ARM Group LLC

Re: Former Coke Oven Area (COA) Interim
Measures Supplemental Investigation
Work Plan
Responses to EPA Comments

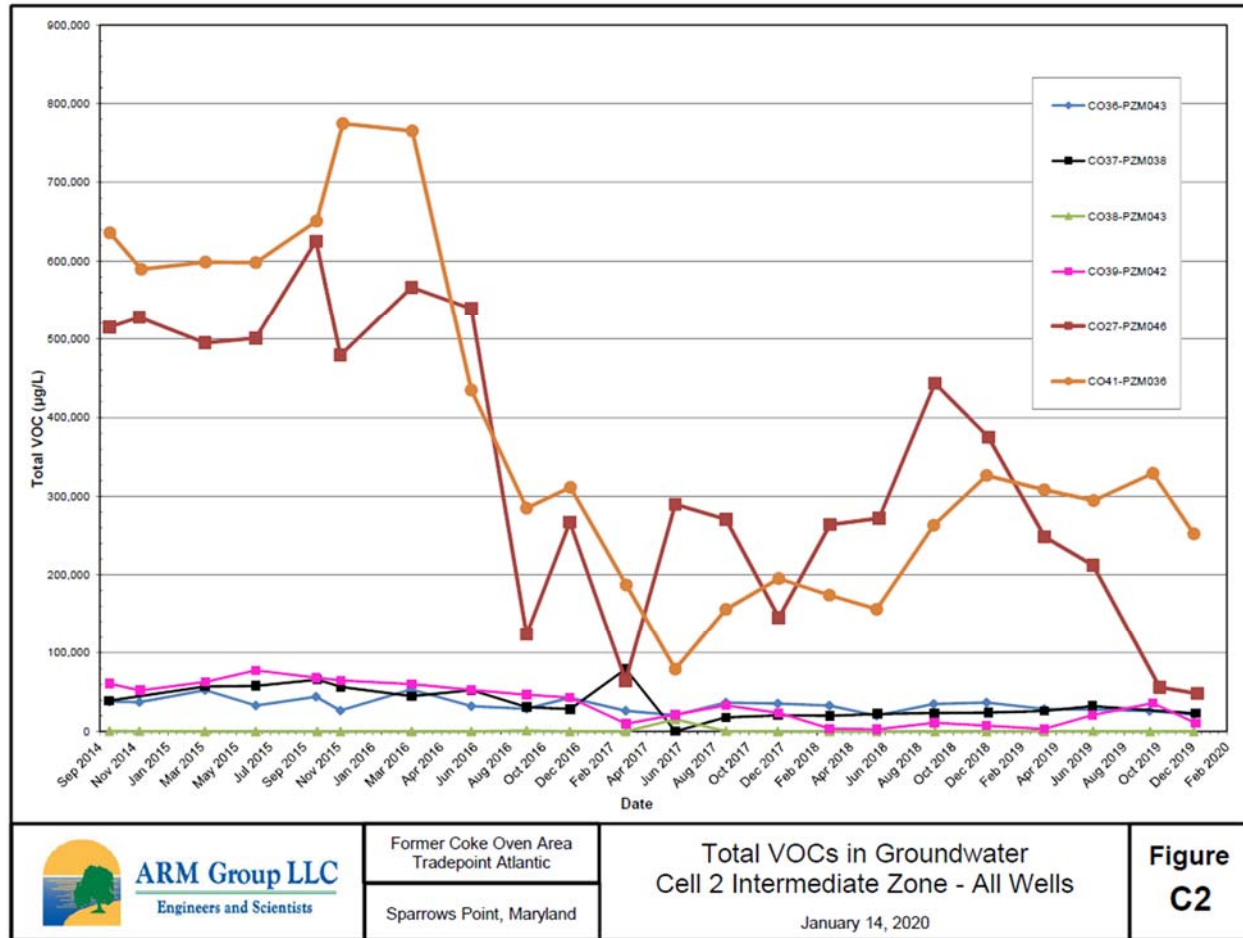
objective. Up to the present the sole means of monitoring progress on the second objective was reporting total mass removed on a continuing basis. Based on that metric, IMs operating at Cells 1, 5, and 6 make progress. However, IMs at Cells 2 and 3 are currently less successful and TPA has shut down operation of Cell 3 and the shallow groundwater remedy at Cell 2. Furthermore, based on other metrics, i.e. downgradient well concentrations, groundwater capture, and surface water impacts it is likely the IMs at Cell 5 and Cell 2 intermediate groundwater are not meeting COA groundwater remediation objectives.

In terms of mass removal, the Cell 2 intermediate zone IM has been highly effective, having achieved greater than 50% reduction in well concentrations (as indicated in the figure below).

As indicated in this time-series chart, the benzene concentration in CO41-PZM036 has decreased by more than 50% from over 600 mg/L to less than 300 mg/L. The benzene concentration in CO27-PZM026 has been reduced about 90% from over 500 mg/L to a current level of less than 50 mg/L. Accelerated mass removal and reductions of benzene concentrations were noted over the past year due to improvements in operations of the Cell 2 system. The Cell 2 pump and treat system was down during the last half of 2018 but repairs to the system allowed nearly continuous operation in 2019, resulting in the removal of 5,800 pounds of hydrocarbons in 2019 compared to 2,700 pounds in the previous year.
